STAFF REPORT

Minor Subdivision
#26-001 Free Eleven Minor Subdivision
Planning Commission Meeting Date: July 7th, 2026
BOCC Meeting Date: August 11th, 2026

REQUEST: Requesting approval for a minor subdivision that will create a total of two (2) lots. Located at 1115 Fremont Street, in Penrose.

Scale 1" = 100'

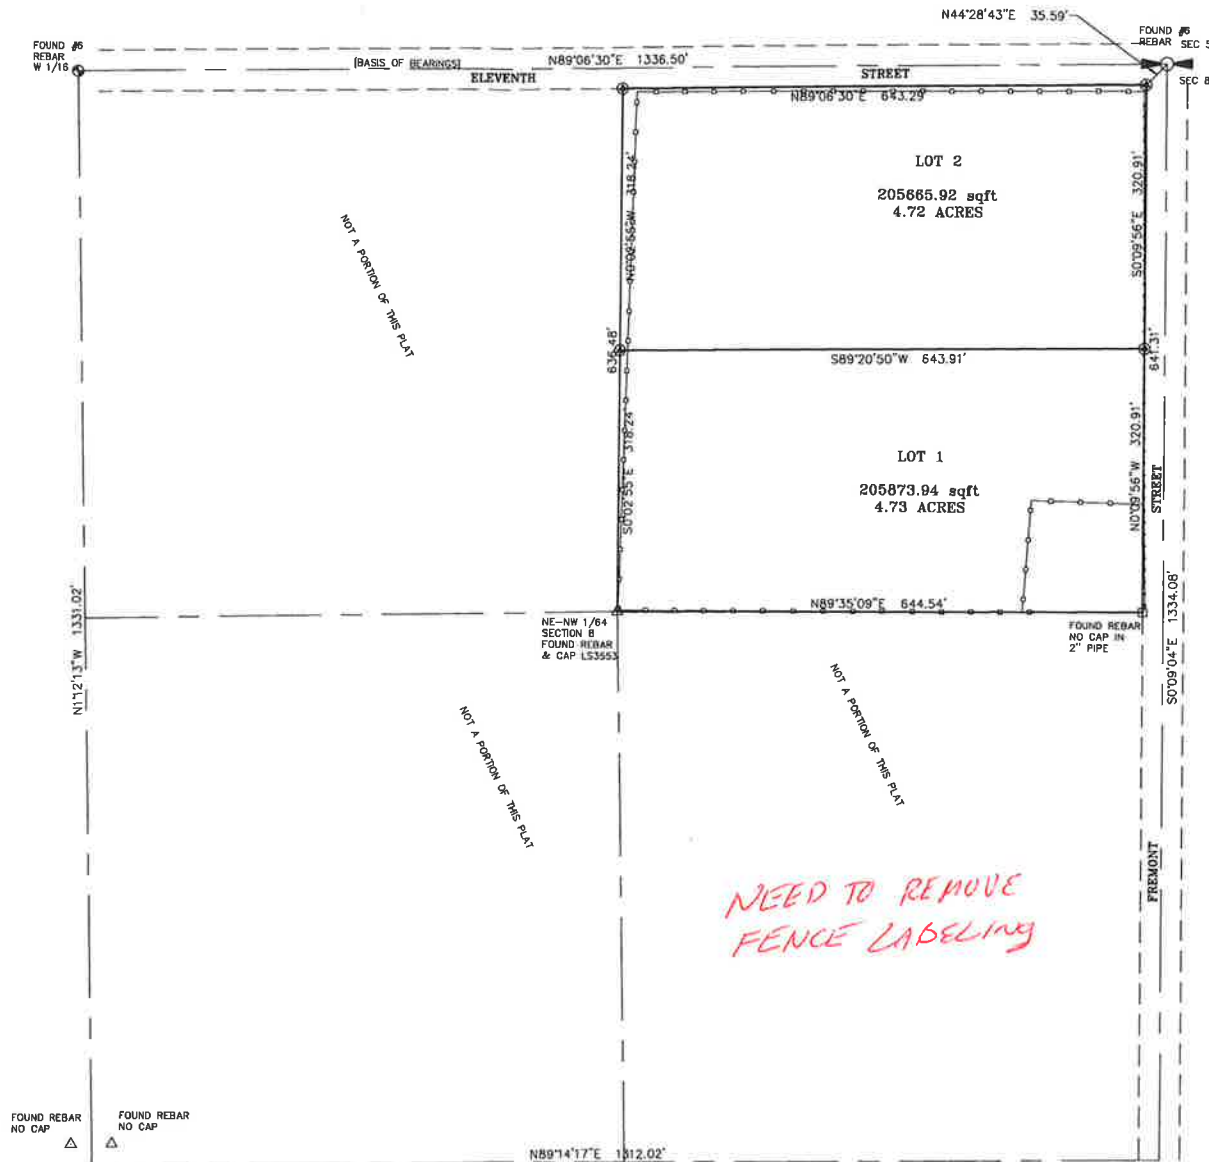
1. Registered Land Surveyor to correct additional red lines.
2. Registered Land Surveyor shall add a note to the plat stating "DRAINAGE PLAN FOR LOT 1 & 2 WAS DEFERRED TO THE TIME OF DEVELOPMENT. THEREFOR PRIOR TO BUILDING, A SITE-SPECIFIC DRAINAGE PLAN WILL BE REQUIRED.
